Duke Power

Subject: Duke Energy Company
Oconee Nuclear Station, Unit 2
Docket Nos. 50-270
Third Ten Year Inservice Inspection Interval
Request for Relief No. 00-01

Attachment 1
ONS Relief Request 00-01
NRC Questions And Duke Answers
July 25, 2000

Figure 1

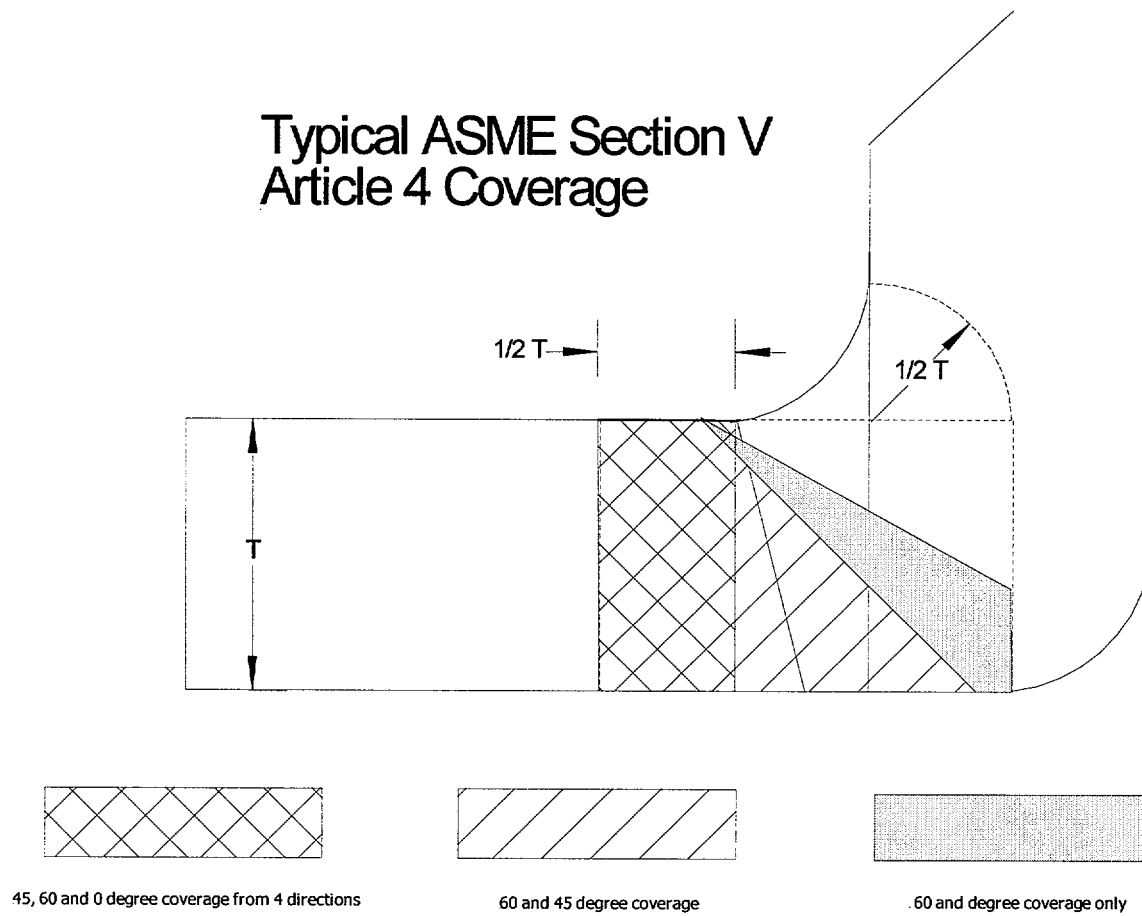
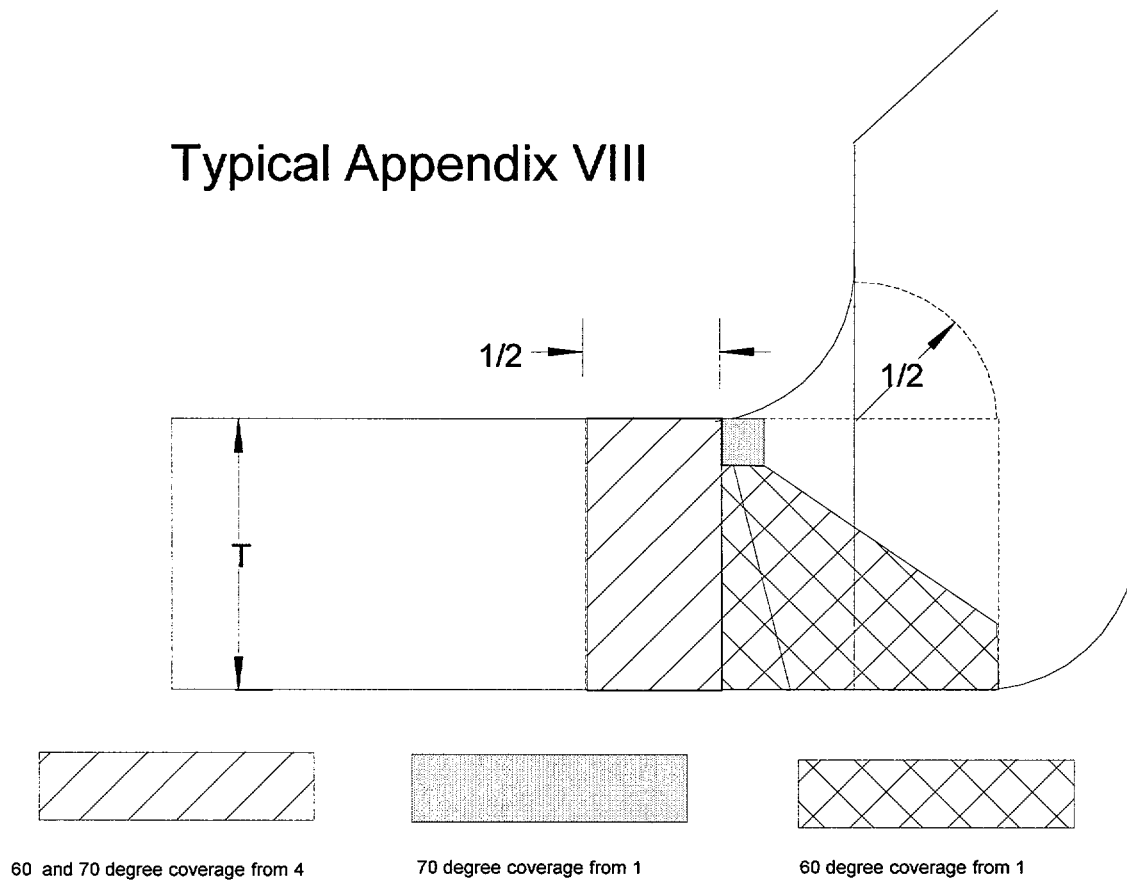
4. Q. Explain the coverage differences between Relief Request 90-01 and Relief Request 00-01 for similar welds. If necessary, use sketches to show the differences. Relief Request 96-01 was granted in a letter to J. W. Hampton, Duke Power Company, from H. N. Berkow, NRC dated December 13, 1996.

A. The differences are the result of using the Appendix VIII procedure vs. the standard ASME Section V, Article 4 methodology. Duke Energy's Appendix VIII procedure requires only two beam angles covering different volumes from four directions. A procedure based on ASME Section V, Article 4 requires coverage of the weld with two beam angles from four directions and coverage of the base material with one beam angle from four directions as a minimum. Coverage of the examination volume with a straight beam search unit is also required (See Figures 1 and 2). The nozzle-to-head configuration allows scanning from only one side. Consequently, no beam angle or combination of beam angles completely covers the required volume. Only the base material on the vessel plate side receives four directional coverage.
